1.2 HISTORICAL PERSPECTIVE OF PCB CONTAMINATION IN CONVAIR LAGOON

1.3 COMPONENTS OF THE PROPOSED CLEANUP PLAN

FIGURE 3-7

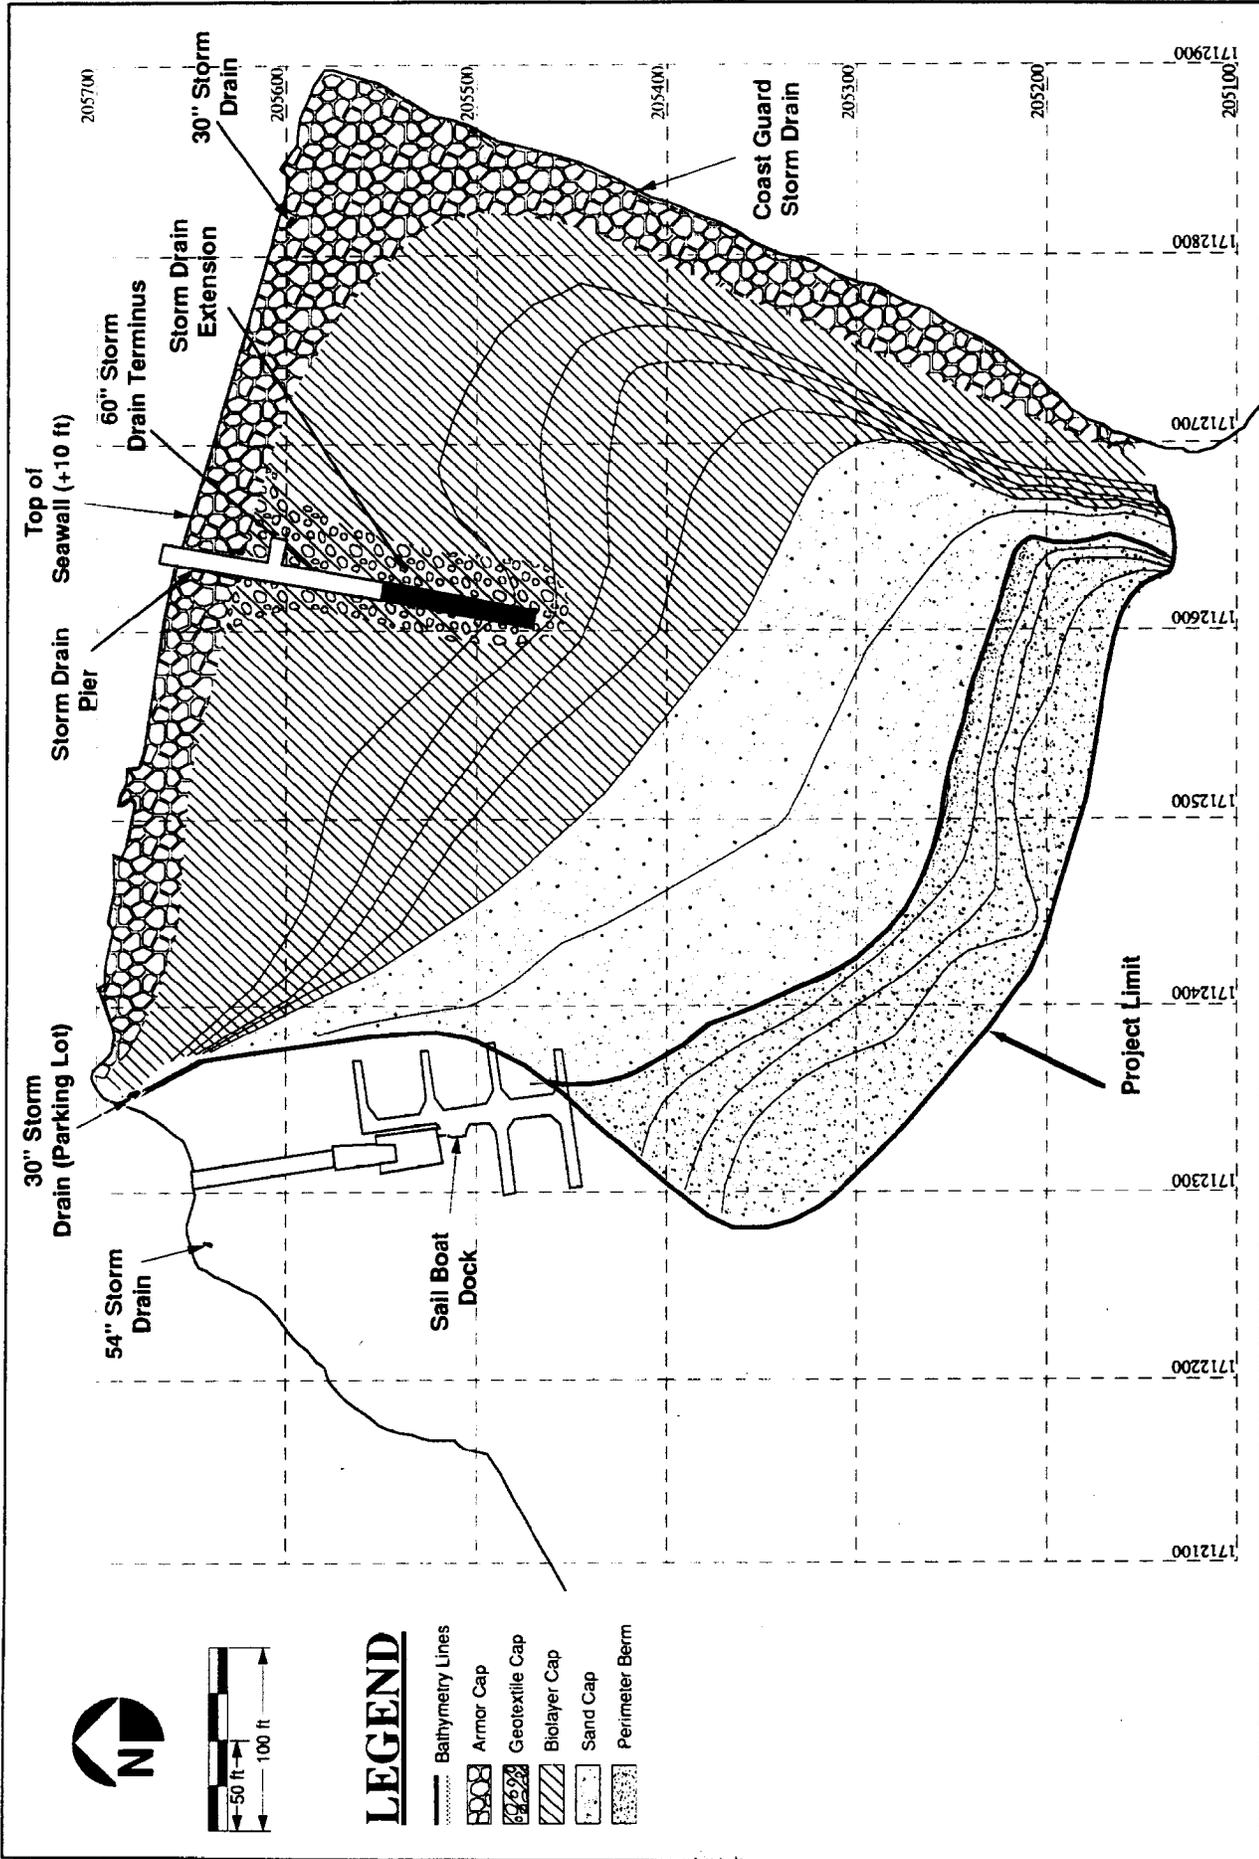
Section 3.4.5.3, page 3-25. A detailed cross section of the proposed high-energy cap is not provided in Figure 3-8. However, if the project, as illustrated in Figure 3-7, is correct, the width of that cap appears to vary between 50 and 100 feet depending on shoreline location. Since this cap will act in part as a fill, mitigation to offset this loss of habitat will be necessary. Quantification of the area of impact and proposed mitigation should be included in the final EIR.

I-3 The location and configuration of the high-energy cap was shown in the conceptual capping plan (Figure 3-7). The need for this type of cap needs to be demonstrated in the design stages by more detailed information on the hydrodynamics of Convair Lagoon. Presently, the concrete seawall will provide more than adequate wave protection with riprap only at the toe. However, given the present shoreline configuration and the riprap slope at the Coast Guard, continuing this slope configuration would provide uniformity and some aesthetic benefits in addition to wave protection. The area of impact is estimated at one to two acres, however this is based on the conceptual cap design, which may vary as the final design parameters are set.
